# UNITED STATES PATENT AND TRADEMARK OFFICE

APPLICATION NO.	FILING DATE	FIRST NAMED INVENTOR	ATTORNEY DOCKET NO.	CONFIRMATION NO.
10/501,619	05/25/2005	Joachim Christ	37742-97114	2228

**Office Action Summary**

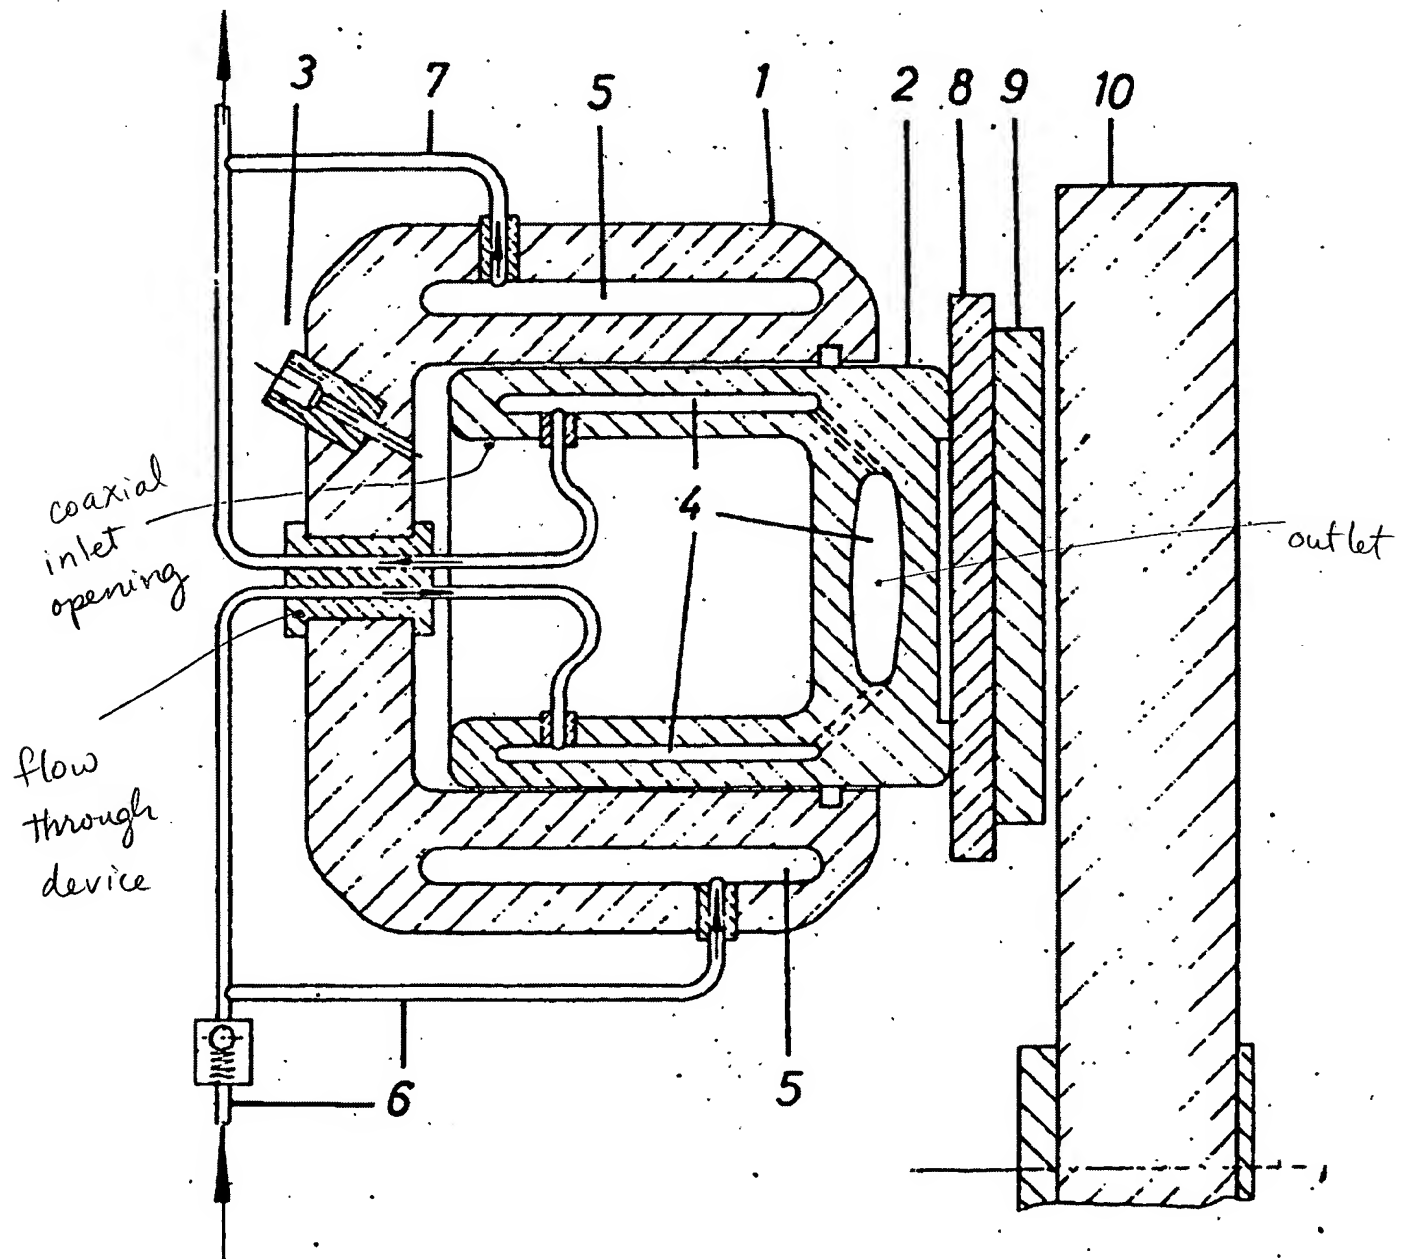
6. Claims 12-14 are rejected under 35 U.S.C. 102(b) as being anticipated by Fuchs (DE 1903437).

Re: claim 1, Fuchs shows a brake caliper in figure 1, as in the present invention, having a caliper wall, the caliper wall defining a cylinder 1 with at least one axially displaceable, hydraulically actuated piston 2 received in the cylinder, with which a brake pad 8, 9 can be pressed against a brake disc 10, the piston defining a cavity 4 therewithin, with at least one inlet opening for feeding a cooling medium into the cavity, the inlet opening being arranged in the piston spaced away from the brake pad, and at least one outlet opening arranged in the piston adjacent to the brake pad for discharging cooling medium from the cavity, as marked below, characterized in that a flow through device, as marked below, extends from the caliper wall into the interior space of the piston to allow passage of cooling medium from outside the caliper wall to the cavity, as shown.

Re: claim 13, Fuchs shows the flow through device to be integral with the wall of the brake caliper, as shown.

Re: claim 14, Fuchs also shows the piston comprises a hollow cylinder, wherein the friction lining 9 is located on one face end of the cylinder and a coaxial inlet opening as marked below, through which the flow-through device extends, is provided in the other face end.
